**TOWN OF BAY HARBOR ISLANDS
PLANNING AND ZONING BOARD**

FINAL AGENDA

HARBOUR PARK APARTMENT BUILDING

Subject: Harbour Park Apartments
9901 E. Bay Harbor Drive
Proposed Revisions from Original PZ Board Approval
Bay Harbor Islands Acct. No. MB2012-39
MMPA Acct. No. 01-0702-0951

Sheet title
ELEVATIONS

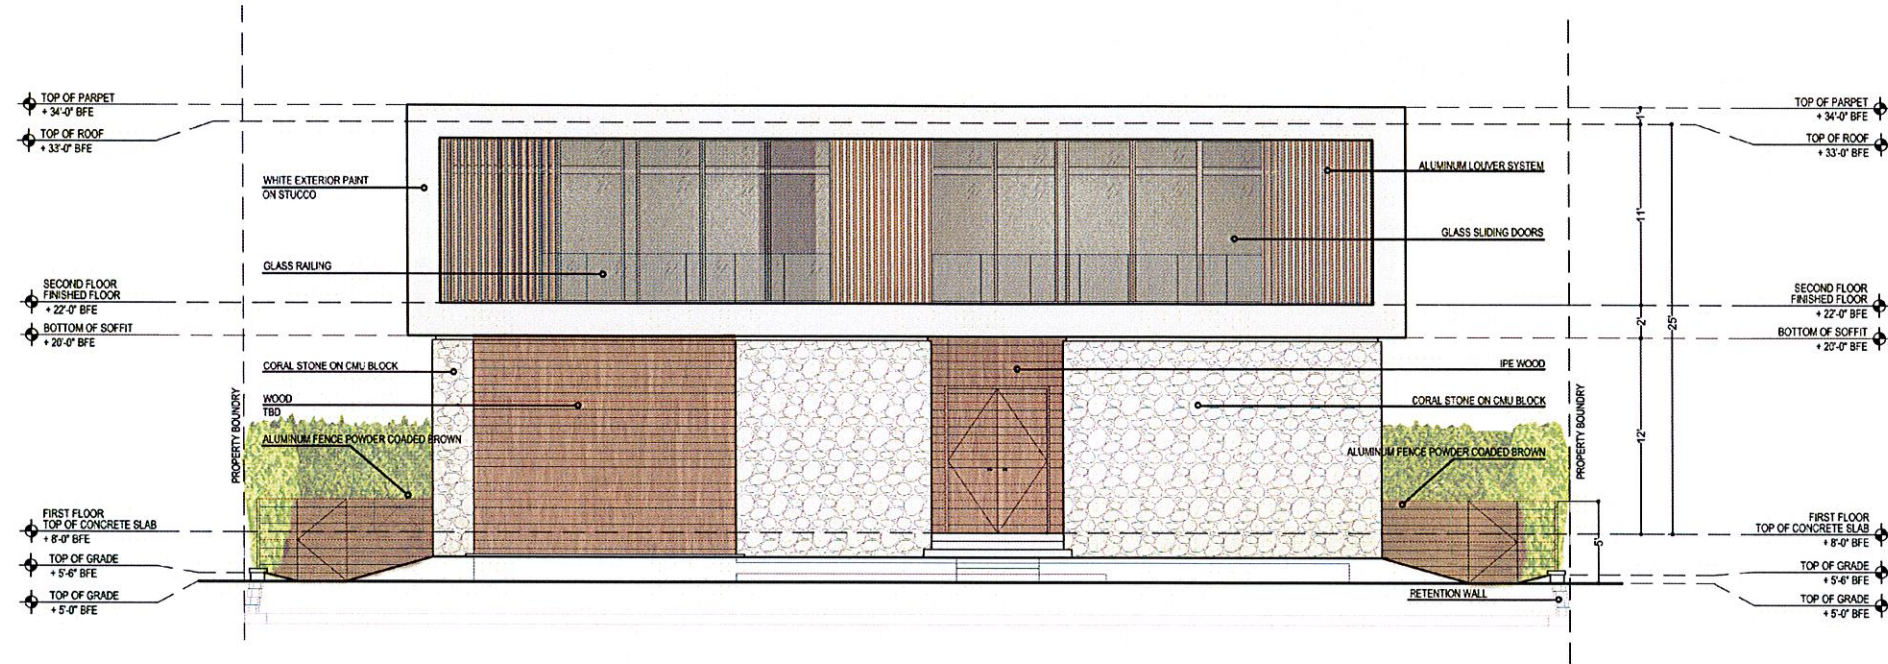
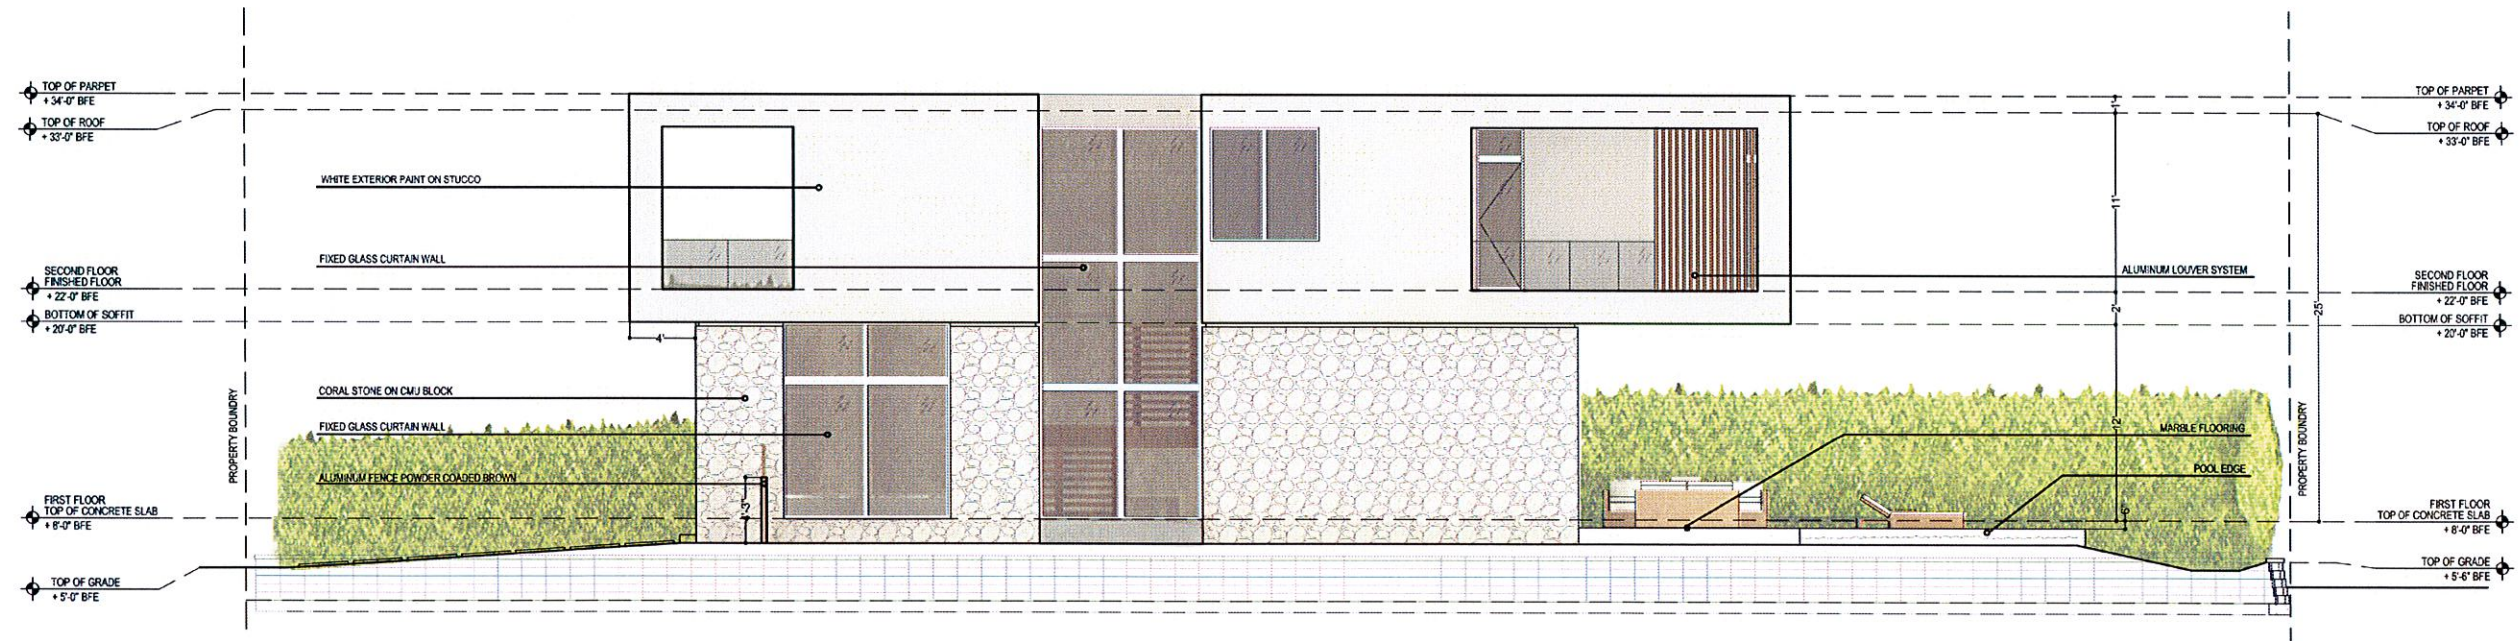
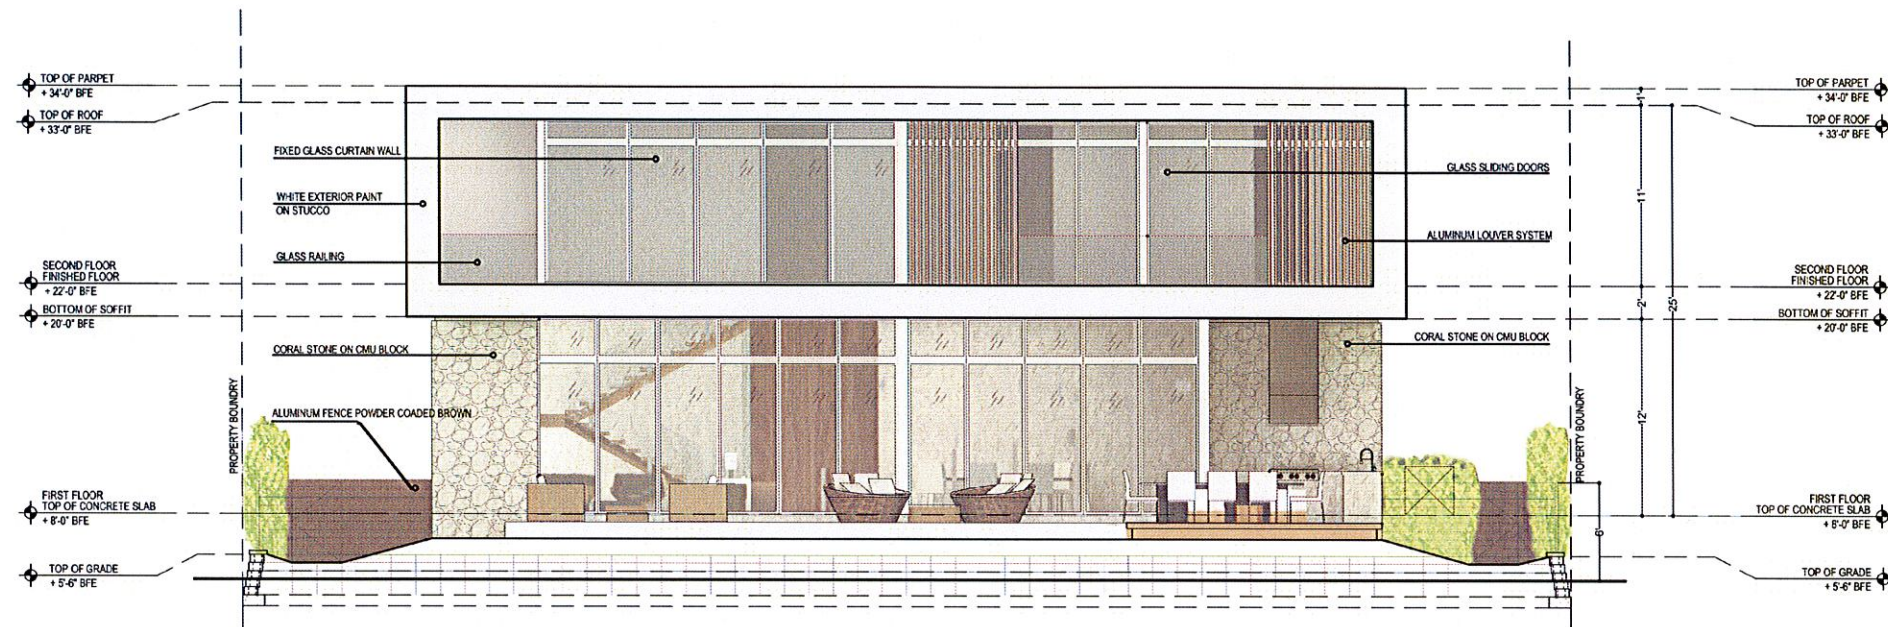
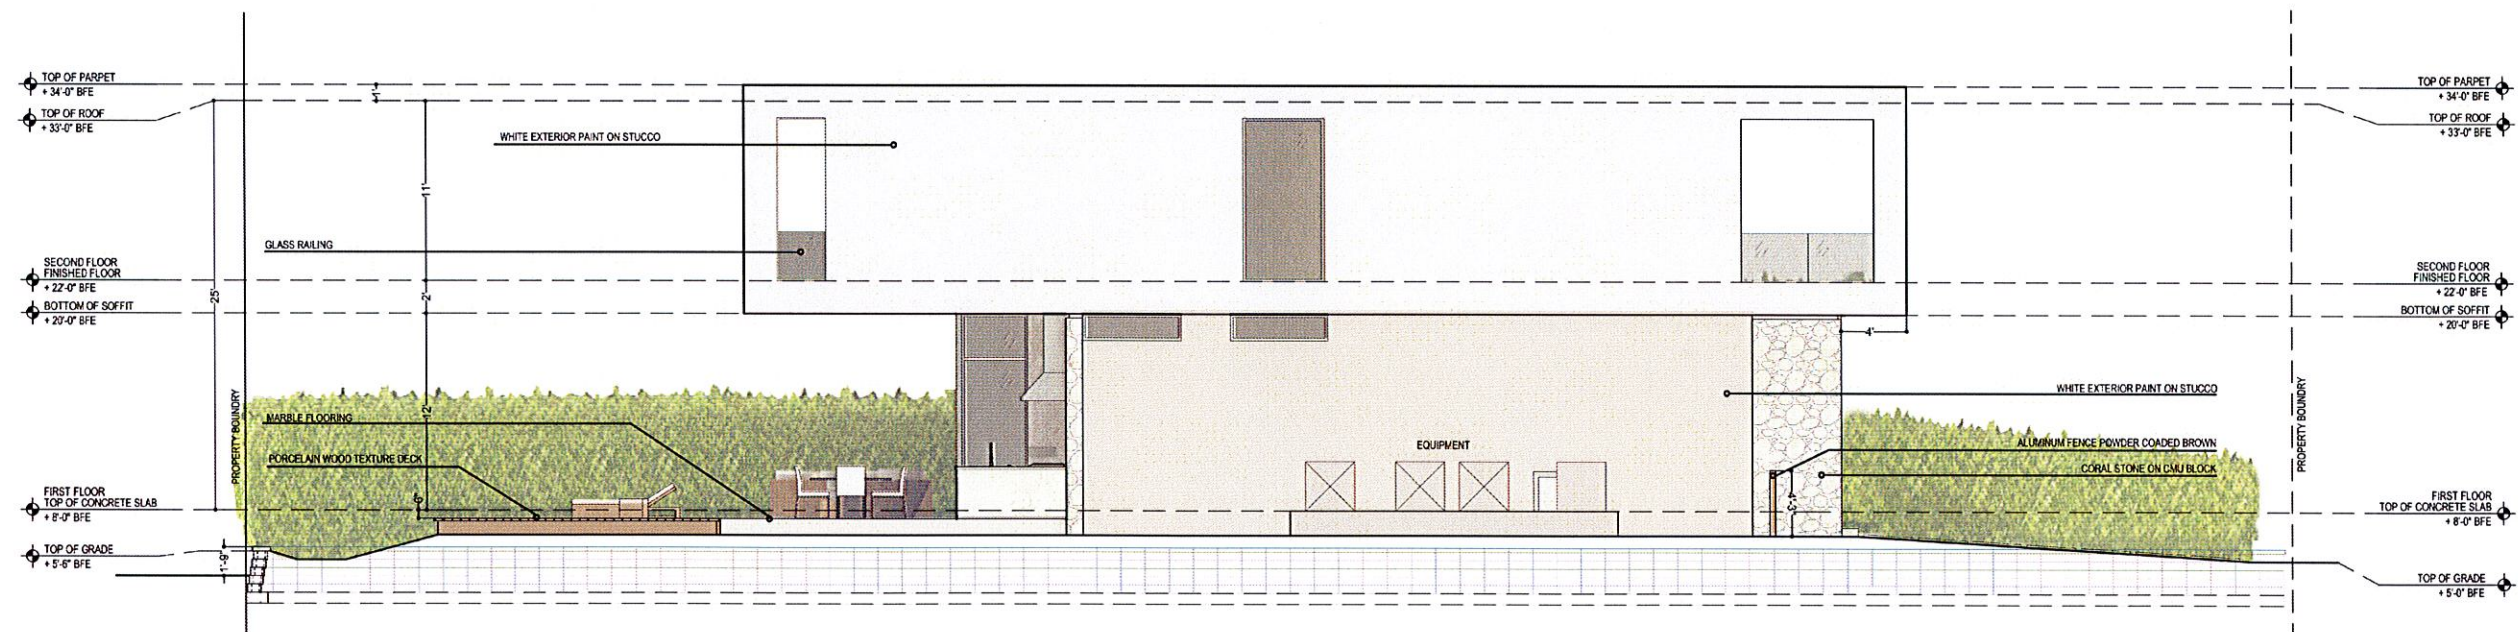
It was felt that the garage door should continue all the way to the slab of the second story. The applicant has since revised the plans to make the height of the garage door that of the first story.

It was felt that the front of the house was too flat and that the second story should have a larger cantilever in the front. The applicant has since revised the plans by sliding the first story of the house several feet toward the rear of the property to allow for a larger cantilever in the front.
